Access Compliance Report Public Rights-of-Way (Curb Ramps)

Main Street: AIROSO_ST		Cross Street: OCASO_ST		Location:	SW
ADA ID: RPRK211124143313	Ramp Type:Type 1 - Perpendicular Diagonal Initial Pass/Fail: Fail		Overall Compliance: No	Severity Score:	15
Codes/Mitigation Info/Possible Solution			Field Measurements/Component Compliance

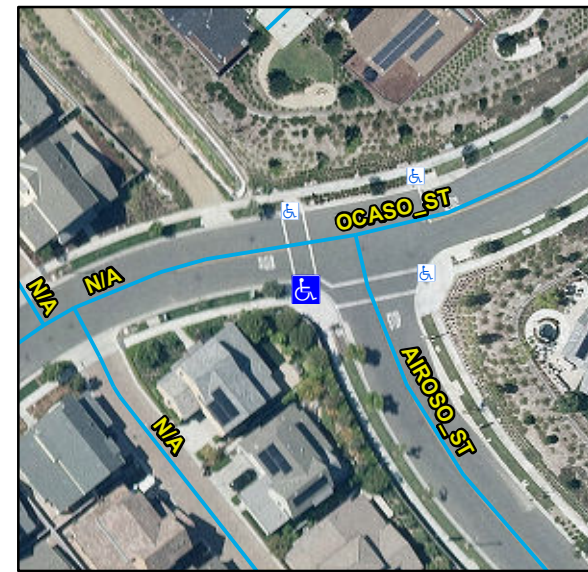
Compliance	Description	Data	Compliance	Description	Data
N/A	Ramp Length (in)	118	N/A	Flare Type LT	
Yes	Ramp Width (in)	48			N/A
No	Ramp Run Slope (%)	9.4	N/A	Flare Slope LT (%)	N/A
Yes	Ramp Cross Slope (%)	1.7	N/A	Flare Traversable LT	N/A
N/A	Landing Present	N/A	N/A	Flare Type RT	
N/A	Landing Length (in)	N/A			N/A
N/A	Landing Width (in)	N/A	N/A	Flare Slope RT (%)	N/A
N/A	Landing Run Slope (%)	N/A	N/A	Flare Traversable RT	N/A
N/A	Landing Cross Slope (%)	N/A	N/A	DWS Provided	N/A
N/A	Landing Movement Obstructed?	N/A	N/A	DWS Contrast	N/A
	Landing Movement Type	N/A	N/A	DWS Length (in)	N/A
N/A	Landing Shared	N/A	N/A	DWS Full Width	N/A
N/A	Clear Space	Yes	N/A	DWS Offset Left (in)	N/A
N/A	Clear Space To Crosswalk (in)	48	N/A	DWS Offset Right (in)	N/A
N/A	Marked Crosswalk 1	Yes	N/A	Marked Crosswalk 2	Yes
	Crossing 1 Direction	E		Crossing 2 Direction	N
	Marked Crosswalk 1 Width (in)	144		Marked Crosswalk 2 Width (in)	144

N/A	Ramp Inside Crosswalk 1	Yes	Yes	Ramp Inside Crosswalk 2	Yes
	Crossing 1 Slope (%)	2.9		Crossing 2 Slope (%)	3.8
	Crossing 1 Cross Slope (%)	1.2		Crossing 2 Cross Slope (%)	5.7
N/A	Gutter Ponding	N/A	No	Curb Slope	9.2
Yes	Gutter Lip Height (in)	0		Road Run Slope (%)	5
N/A	Gutter Run Slope (%)	N/A		Road Cross Slope (%)	3.2
N/A	Gutter Cross Slope (%)	N/A			
Yes	Overall Surface Condition: Acceptable		Yes	Perp Joint Present	Yes
	Cross Gutter Present?	No		Spandrel Present?	No
	Replace Cross Gutter?	N/A		Replace Spandrel?	N/A

Remove & Replace Curb Ramp With Two New Directional Ramps or Equivalent.
